Re: FortisBC Energy Inc. (FEI)

**Application for a Certificate of Public Convenience and Necessity (CPCN) for
Approval of the Coastal Transmission System Transmission Integrity
Management Capabilities Project (Application)**

**Response to the British Columbia Utilities Commission (BCUC) Information
Request (IR) No. 1**

Cumulative Rate Impact

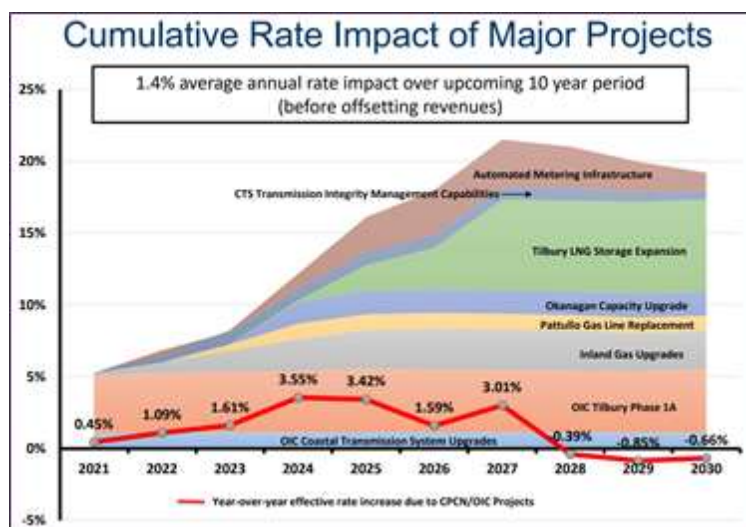
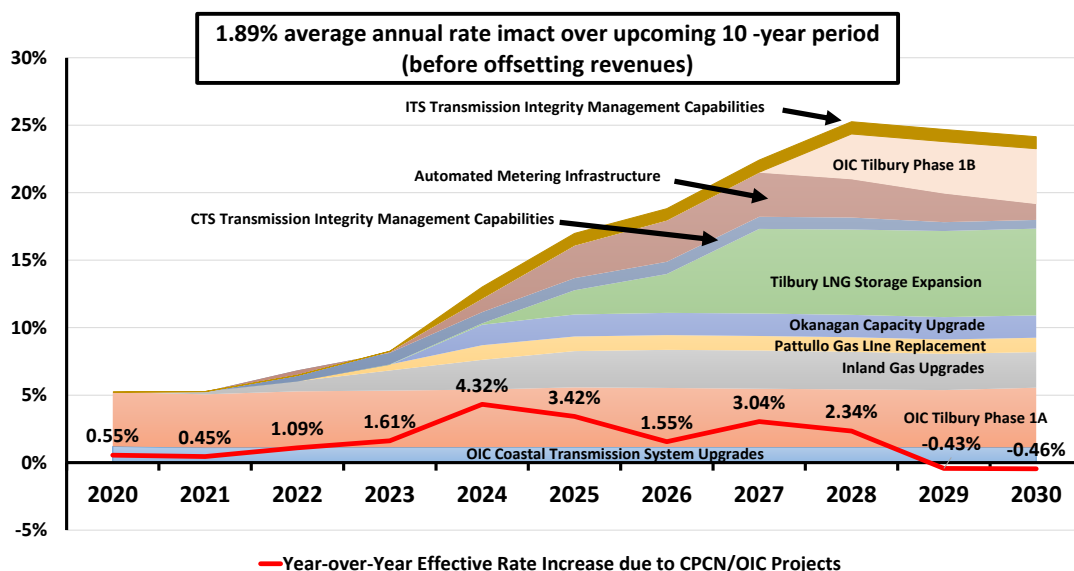
On page 5 of FEI's CTS TIMC Project Workshop Presentation, FEI shows the cumulative rate impact of major projects of 1.4% average annual rate impact over the upcoming 10-year period, which has been reproduced below.

29.1 Please provide an updated chart to include the ITS TIMC CPCN, Woodfibre Gas Pipeline project and Tilbury Phase 1B project directed by Order in Council. As part of the response, please confirm the average annual rate impact over the upcoming 10-year period as a result of these projects and include the rate impact of each individual project.

- The Woodfibre Gas Pipeline would be subject to the demand toll under Rate Schedule (RS) 50 for large volume industrial transportation customers,¹⁵ which is designed to recover the incremental cost of service required for the system upgrade. FEI is not expecting a rate impact to FEI's non-bypass customers, and therefore, has not included any rate impact related to the Woodfibre Gas Pipeline project in the figure below.

- As noted above, FEI has not developed a cost estimate for the ITS TIMC project. In the figure below, FEI has assumed the ITS TIMC project would have a similar rate impact as the CTS TIMC Project and that it would enter rate base in 2024.

As described in the Workshop, the figure below does not include any offsetting revenues stemming from increased capacity/demand or RS 46 revenues that would offset the rate impact of Tilbury Phase 1A. The same applies to the addition of Tilbury Phase 1B. FEI also notes the actual rate impact for FEI will not be dependent on these projects alone. There are various factors that will affect FEI's revenue requirement such as the demand forecast, taxes, O&M expenses, and other capital additions (beside these OIC and CPCN projects). As such, the figure below is illustrative only and does not represent FEI's estimated rate increase for the years shown.
